Northern Pacific Railway Company.
Engineering Department Records.

FILE NO. 381

ALGONA ROAD HIGHWAY BRIDGE

AUBURN, WASH.

N.P.R.
Seattle Div. — Main Line
AUBURN YARD
Sketch showing proposed
Overhead Crossing for Algona Road
South of Auburn, Wash.
Office of Engr. Maint. of Way, Tacoma, Wash.
Jan. 12-1912

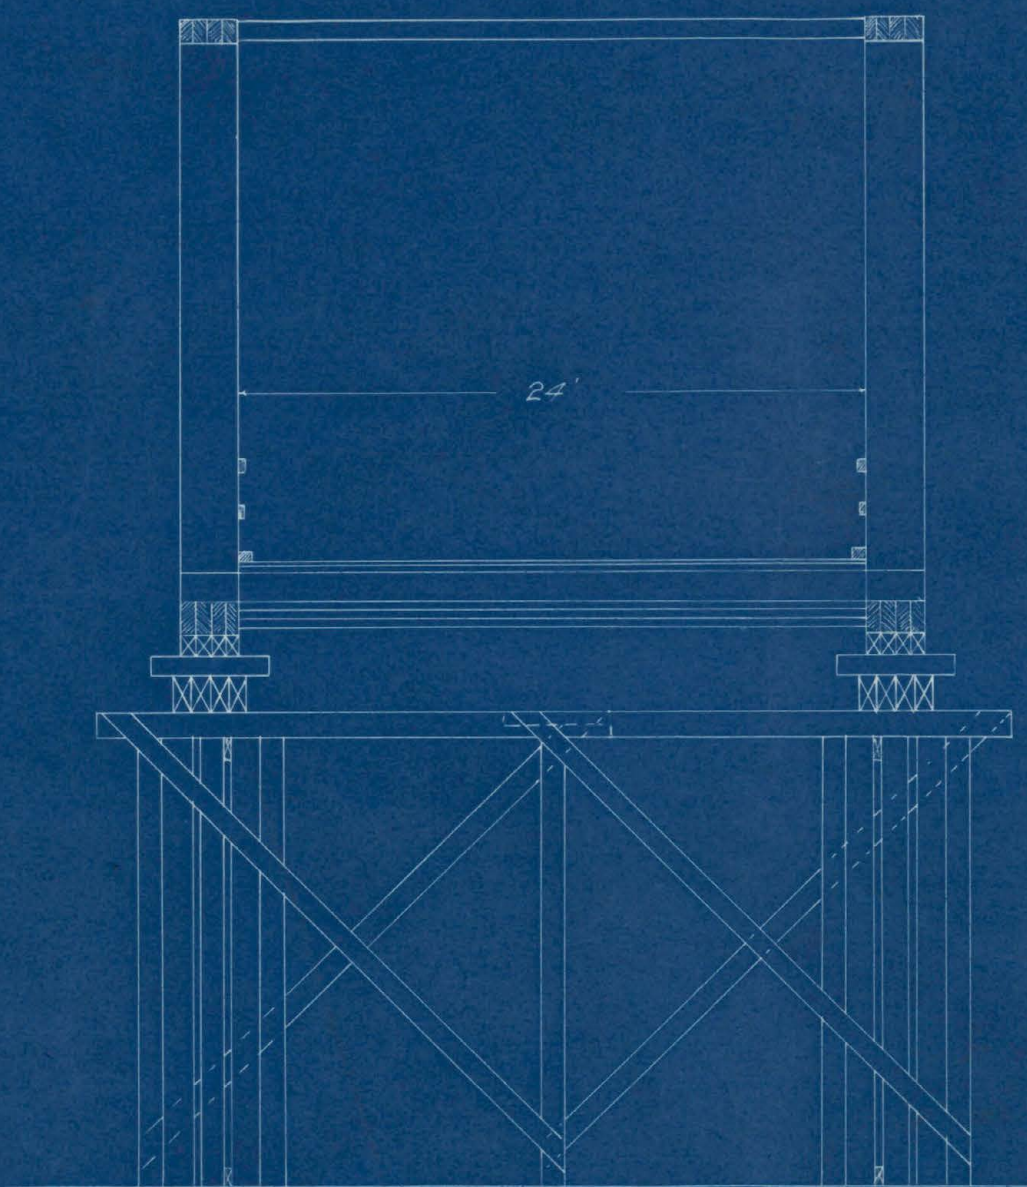
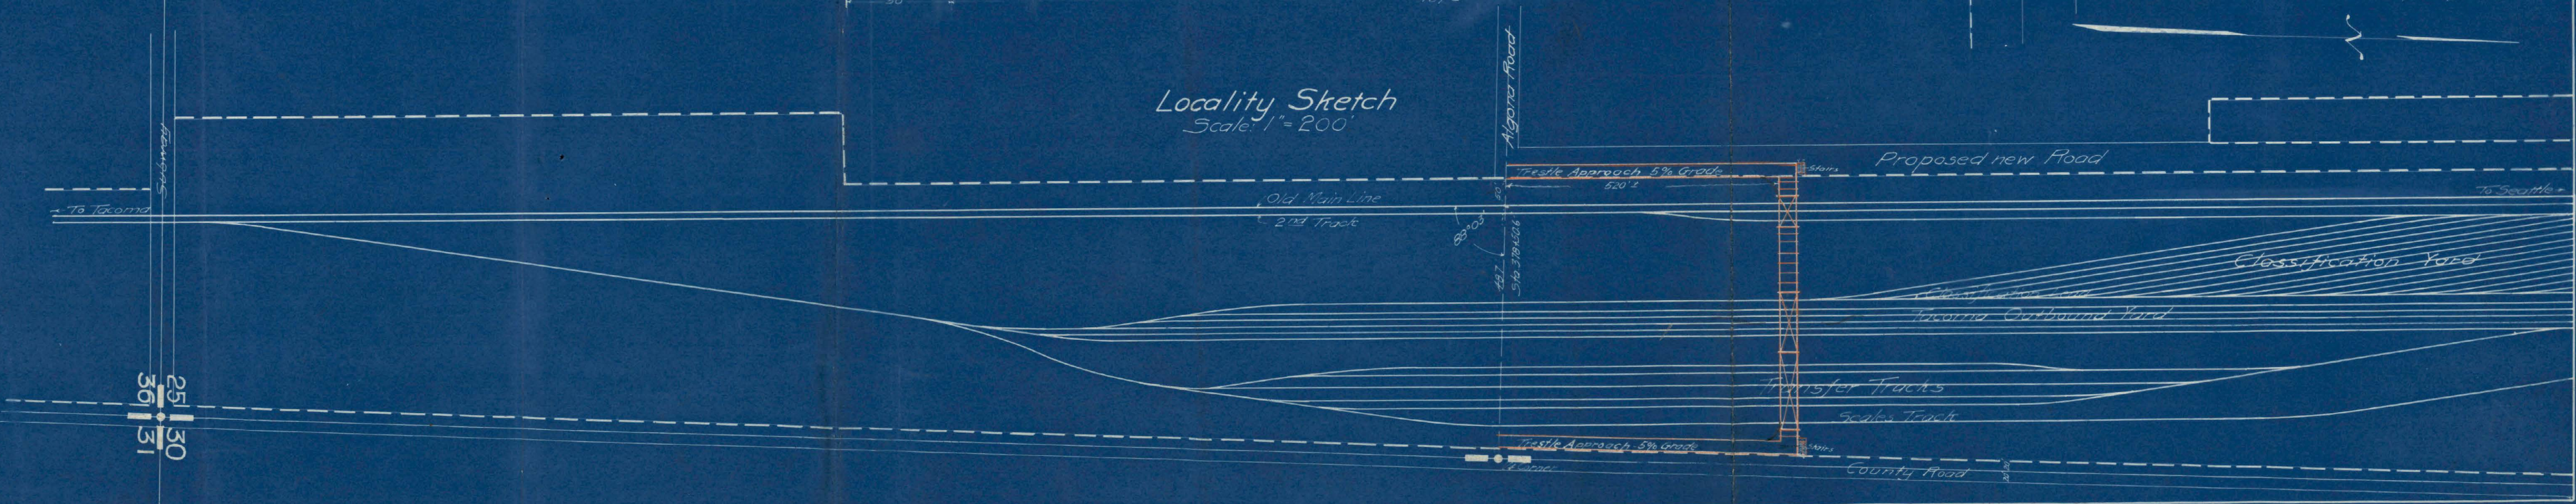
If possible, would like to secure these before the end of the month. We are up against it now, as we cannot extend the yard across the Algona Road and complete work of track laying and surfacing until this viaduct is constructed.

Possibly your plans are in such shape that we could order the material for the approaches and get started on those, which would relieve the situation somewhat, and probably make it possible for us to operate at lease one track at grade, so that the people in the vicinity have an evidence of good faith in the way of starting work.

You will note that it has been necessary, in order to procure the approval of the County Commissioners, to change the approach to a five per cent grade. How will this affect the estimate upon which Mr. Perkins has based the AFE, the original of which I think you prepared?

I have made estimate of the cost of this as per Mr. Perkins' letter, and the plan which he submitted, showing the approaches at 5% grades, and find that the total cost is practically the same as what Mr. Stevens estimated. Mr. Stevens' estimate is based on 2,000 ft. of structure with four approaches at 7% grade; the revised estimate attached is for about 1,490 ft. of structure with two approaches at 5% grade. Although the structure has been shortened about 500 ft. the increased length of Howe Truss spans will bring the estimate up to practically what it was before. Am attaching an estimate of cost.
